Dental- Information

Sirona Dental Systems • Fabrikstrasse 31 • D-64625 Bensheim

June 2002

Wiring diagrams for C4⁺: correction of wiring layout for X-ray viewer

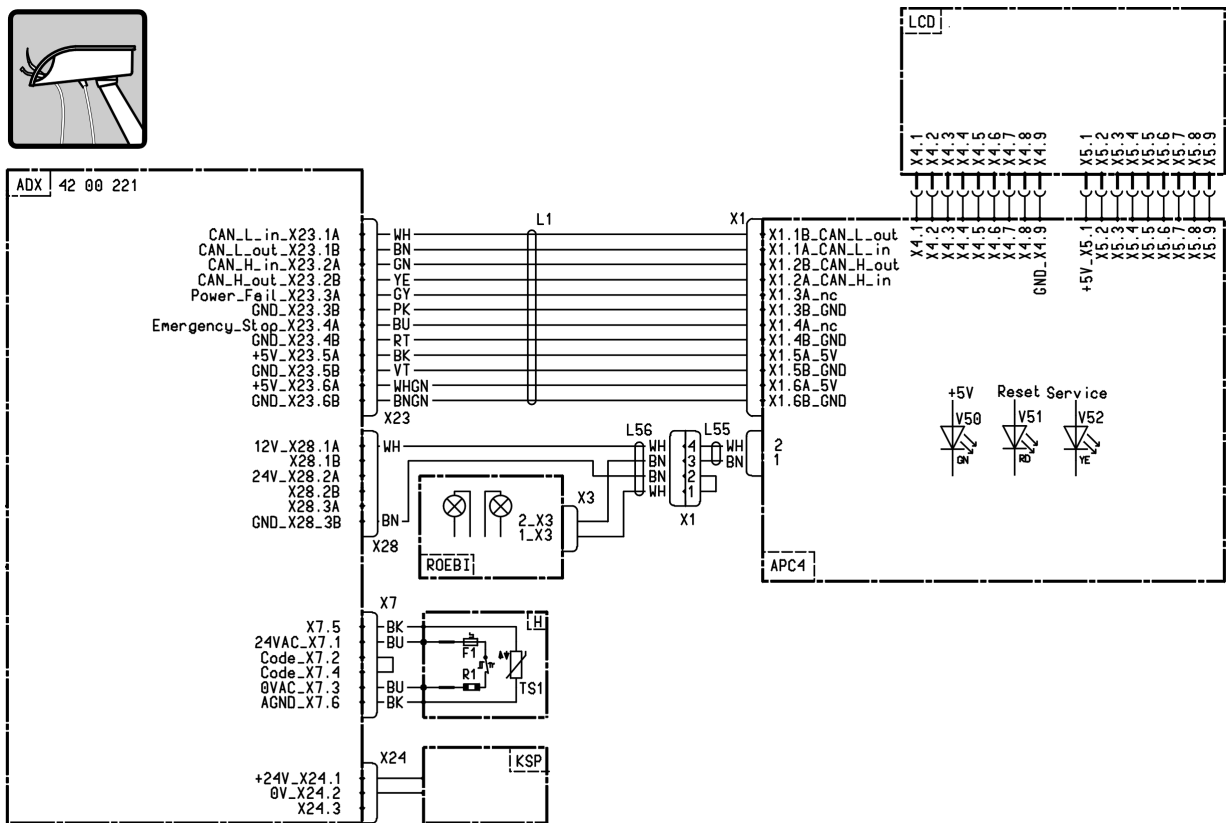
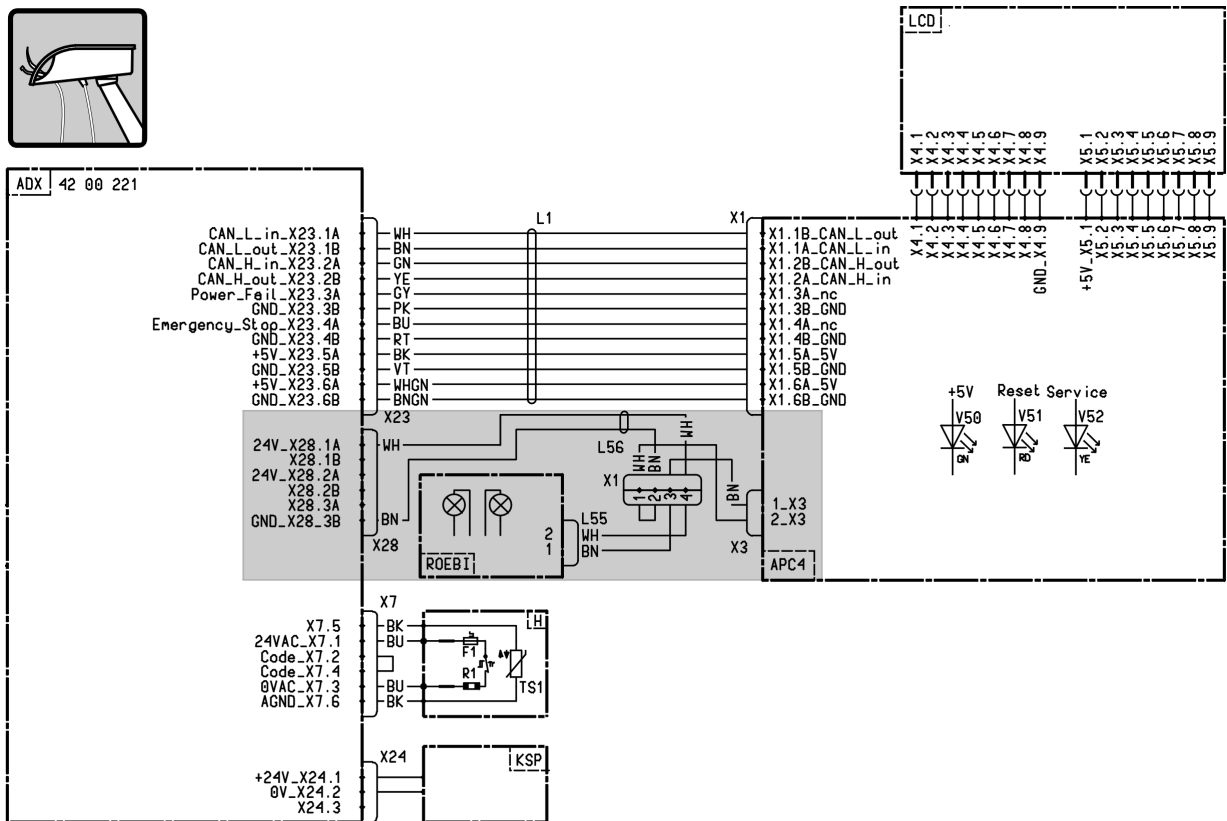
Sheet 2A of the **wiring diagrams for the C4⁺, REF. 59 02 981** shows an incorrect wiring layout for the X-ray viewer attached to the dentist's element. The correct layout is shown on the following page. The wiring diagrams supplied together with the treatment centres will be corrected as soon as possible.

Correct

Sensor plug sleeve

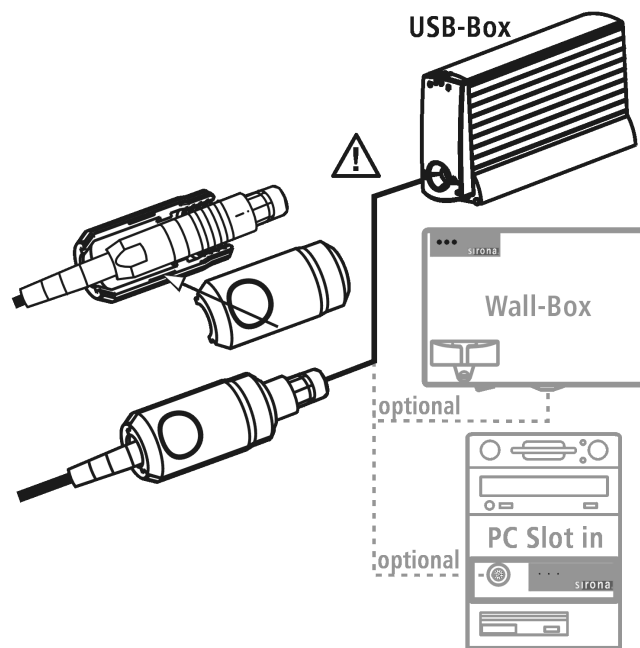
With effect from June 2002, the **sensor plug sleeve (REF. 59 22 187)** will be supplied automatically together with **all** sensors (1 x per sensor). Previously, this plug sleeve had been restricted to the USB Box.

Please note that the plugs used in combination with the USB Box must **always** be fitted with the above-mentioned sleeve. In the case of the wall box and the PC slot-in, the plug sleeve is optional.
